PROJECT NARRATIVE

TMPPL2026000092 – Substantial Conformance Application – Steamboat Basecamp

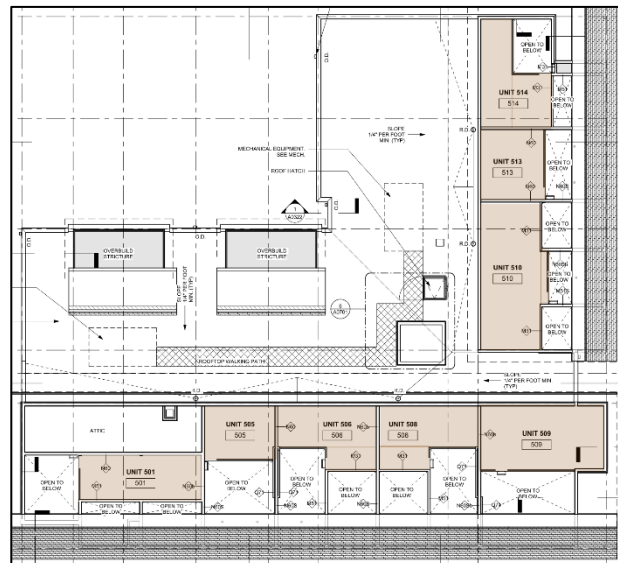
2) Lofted Mezzanine Areas

The Applicant proposes adding lofted mezzanine areas within eight (8) of the fifth-floor units that fall within the approved pitched roof area, as shown in the image below. These areas are intended as open-to-below den/office/storage space (NOT additional bedrooms). The estimated net increase in gross floor area is 2,425 SF (per the chart below), which remains under the 5% threshold. There is no proposed change to the approved roof form or pitch.

EXHIBIT B

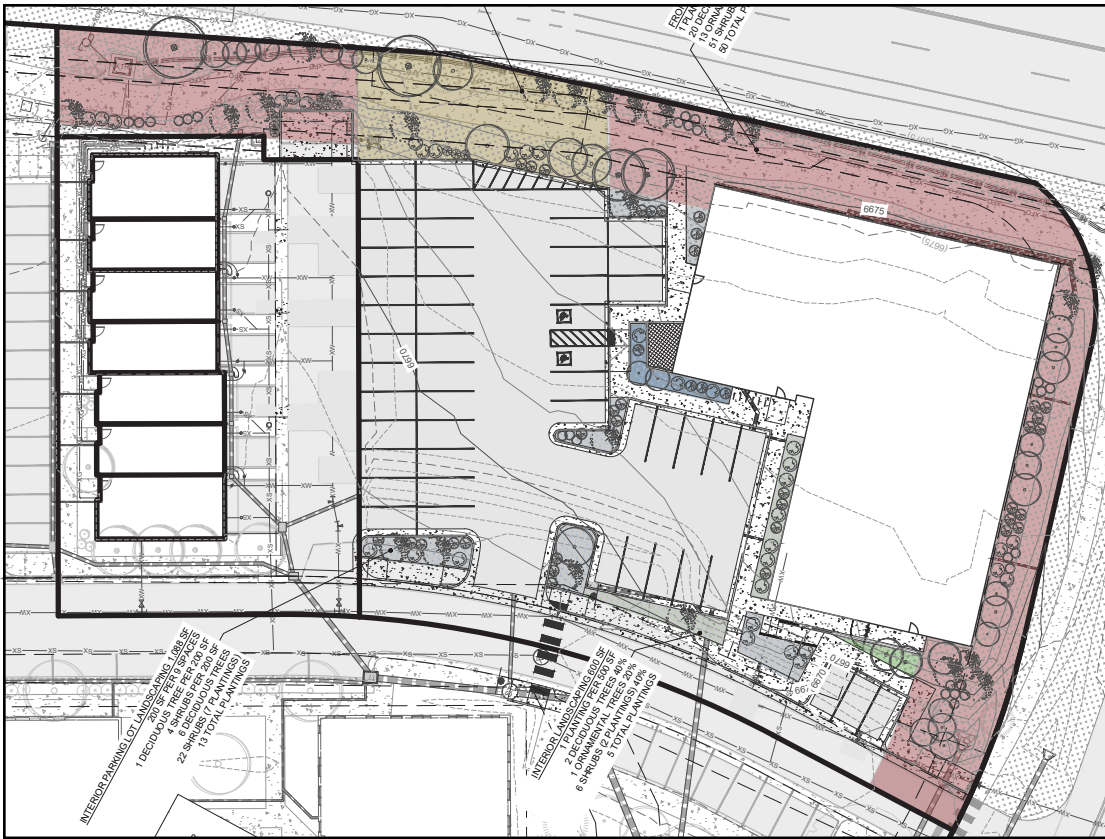
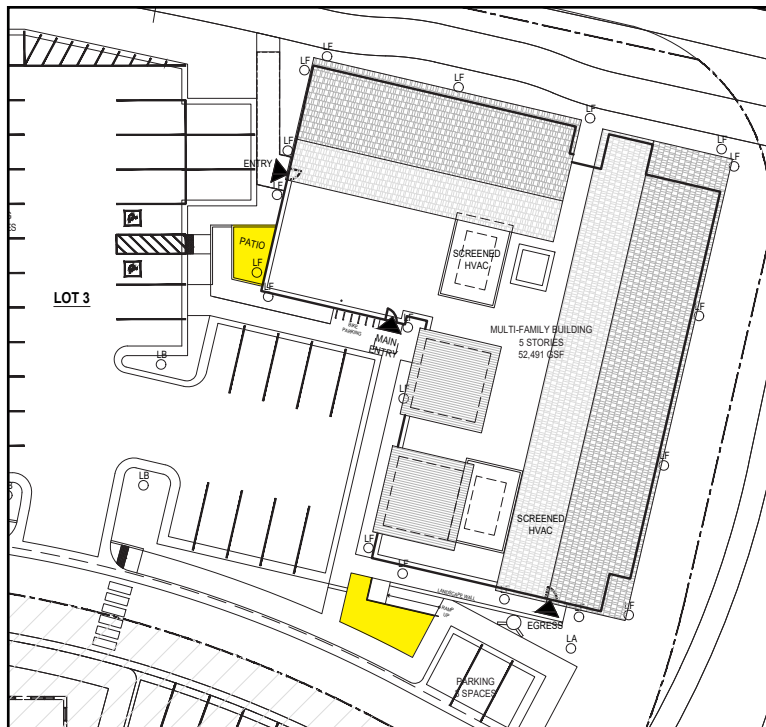
4) Landscaping Changes. As a result of the rearranged parking area changes noted in item #3 above, the landscaping has also experienced change around the building entry area. Approximately the same quantity of plantings in the approved DP landscaping plan will be provided, just in slightly different locations (actually, three more plantings are proposed). The total amount of landscaped area has only varied by -0.43%, well below the 5% threshold. The difference between the approved Development Plan landscaping areas and those shown on the Permit Set are graphically shown in **Exhibit B** of this narrative.

FRONTAGE:
14,529 SF
50 PLANTS

PARKING LOT SETBACK:
15,250 SF
13 PLANTS

INTERIOR PARKING LOT:
2,155 SF
28 PLANTS

INTERIOR:
3,007 SF
5 PLANTS

FRONTAGE:
14,599 SF (0.48% CHANGE)
52 PLANTS (4% CHANGE)

PARKING LOT SETBACK:
15,250 SF (0% CHANGE)
13 PLANTS (0% CHANGE)

INTERIOR PARKING LOT:
2,059 SF (4.45% CHANGE)
29 PLANTS (3.57% CHANGE)

INTERIOR:
2,981 SF (0.86% CHANGE)
5 PLANTS (0% CHANGE)

AMENITY SPACE

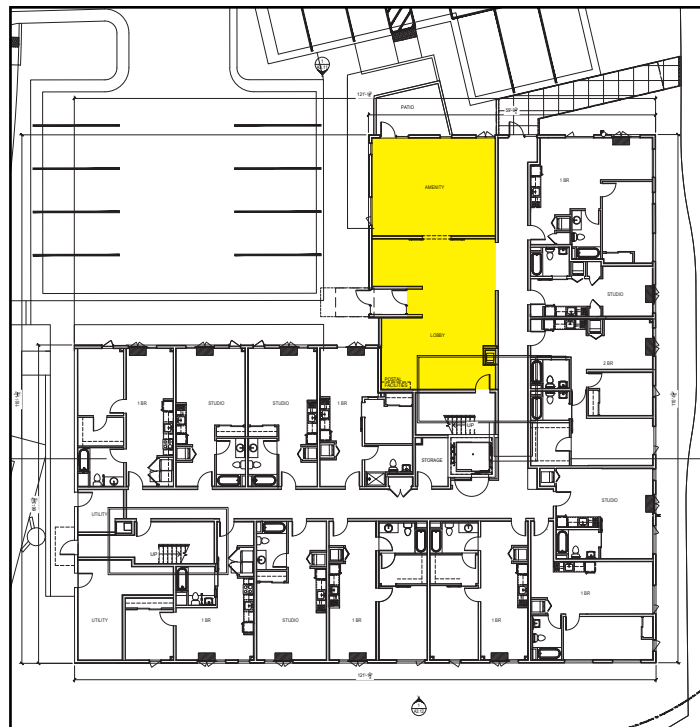
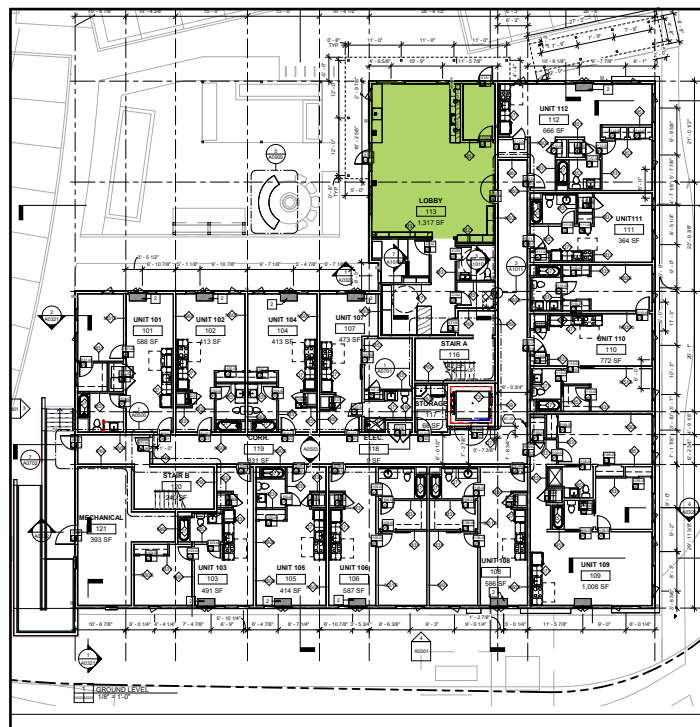
5) Amenity Area. Through the course of design development, some shifts have occurred in both the indoor and outdoor amenity spaces. The indoor amenity space decreased in size due to the programming of various necessary elements of the ground floor, namely a public restroom, a property management office, a package storage closet, and resident mail/package area. However, the exterior amenity space has grown due to the parking area adjustments noted in item #3 above. The aggregate of both the interior and exterior amenity spaces have not varied by more than the 5% threshold as shown in the chart below. The difference between the approved Development Plan Amenity areas and those shown on the Permit Set are shown graphically in **Exhibit C** of this narrative.

**DEVELOPMENT SUBMISSION
SITE PLAN
374 SF EXTERIOR AMENITY**

**DEVELOPMENT SUBMISSION
GROUND FLOOR PLAN
1,276 SF INTERIOR AMENITY**

**PERMIT SUBMISSION
SITE PLAN
831 SF EXTERIOR AMENITY**

**PERMIT SUBMISSION
GROUND FLOOR PLAN
876 SF INTERIOR AMENITY**

**TOTAL DEV. SUB. AMENITY AREA: 1,650 SF
TOTAL PERMIT AMENITY AREA: 1,707 SF
CHANGE IN AREA: 57 SF (3.47%)**
